PARTS LIST FOR MODEL SLAMMER IV 3500  
**SLAiV3500 (1545761)**

**MRP Ver. 053122**

(based on Penn's Rev. 00 4-20-21)

## Penn Reel Parts list for Model: SLAiv3500 (1545761) SLAMMER iv SPINNING

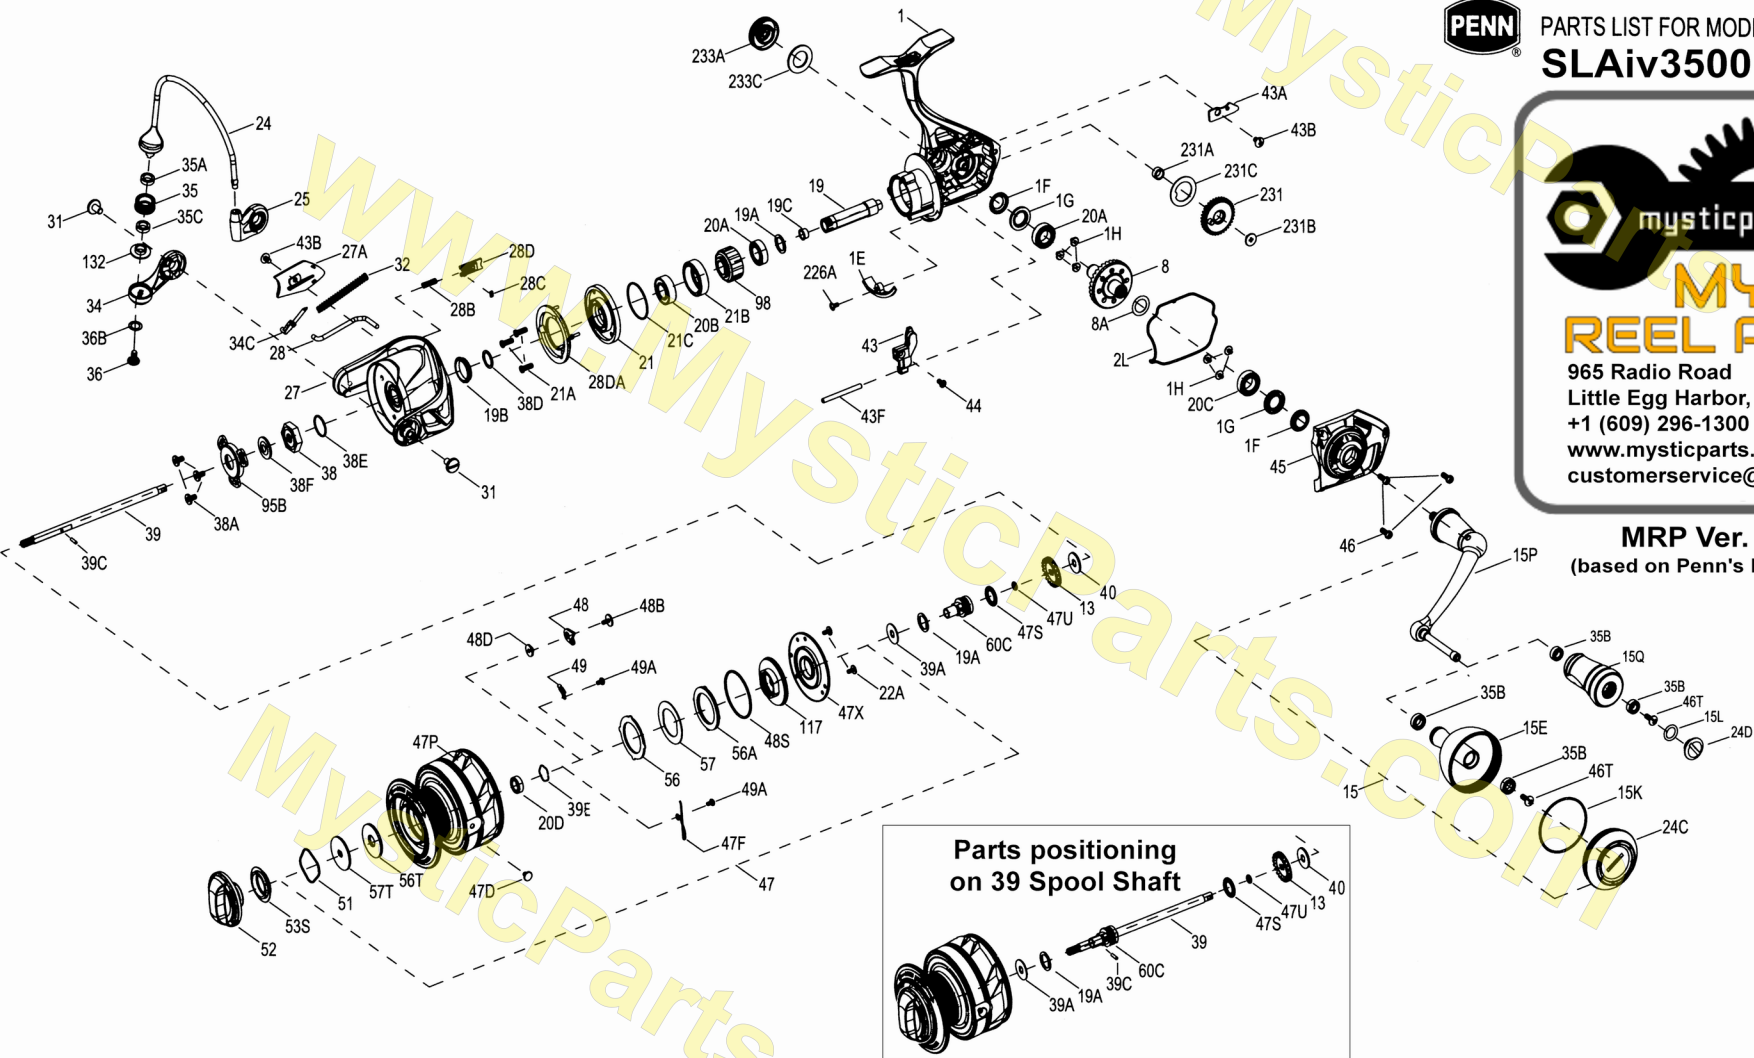
21C	1418981	21C-SLA3500		BODY HEAD SEAL
22A	1418982	22A-SLA3500		DRAG COVER SCREW (2 REQUIRED)
24	1559199	24-SLAiv3500		BAIL WIRE
25	1385539	25-CLA3000		BAIL HOLDER
27	1559201	27-SLAiv3500		ROTOR
27A	1559202	27A-SLAiv3500		ROTOR COVER
28	1559203	28-SLAiv3500		ROTOR TRIP LEVER
28B	1346982	28B-CLA2000		SPRING
28C	1385547	28C-CLA3000		ROTOR BRAKE SEAL
28D	1385545	28D-CLA3000		ROTOR BRAKE (RECTANGULAR)
28DA	1418967	28D-SLA3500		ROTOR BRAKE (ROUND)
31	1276936	31-SSV3500		BAIL ARM SCREW (2 REQUIRED)
32	1385549	32-CLA3000		BAIL SPRING
34	1385550	34-CLA3000		BAIL ARM
34C	1385551	34C-CLA3000		PIVOT ARM
35	1559204	35-SLAiv3500		LINE ROLLER
35A	1474155	35A-SLAiii3500		LINE ROLLER BUSHING
35C	1525199	35C-CLAi3000		LINE ROLLER BALL BEARING
36	1277061	36-SSV5500		LINE ROLLER SCREW
36B	1417809	36B-CLA6000		BAIL ARM SCREW WASHER
38	1418993	38-SLA3500		ROTOR NUT
<b>38A</b>	<b>SEE PROBLEMS FOUND PAGE 3</b>			
38D	1559205	38D-SLAiv3500		WASHER, ABOVE RETAINER

Penn's rev00 schematics list the 15L as 15L-CLA2000 on SLAiv2500, SLAiv2500HS, SLAiv3500, SLAiv4500 & SLAiv4500HS (INCORRECT PART#)

15L-CLA2000 are much smaller and thinner than the seal that was found on the 24C-CLA3000 caps during disassembly.

38A	<del>1119121</del>	<del>20G-7000AF</del>	SCREW (3 REQUIRED) ** INCORRECT PART NUMBER DO NOT USE
	1277063	38A-SSV5500	SCREW (3 REQUIRED) ** USE THIS PART

We could not identify an existing Penn number to match it to, so we have assigned the number as **15L-CLA5000** Seal (Thicker/Larger)
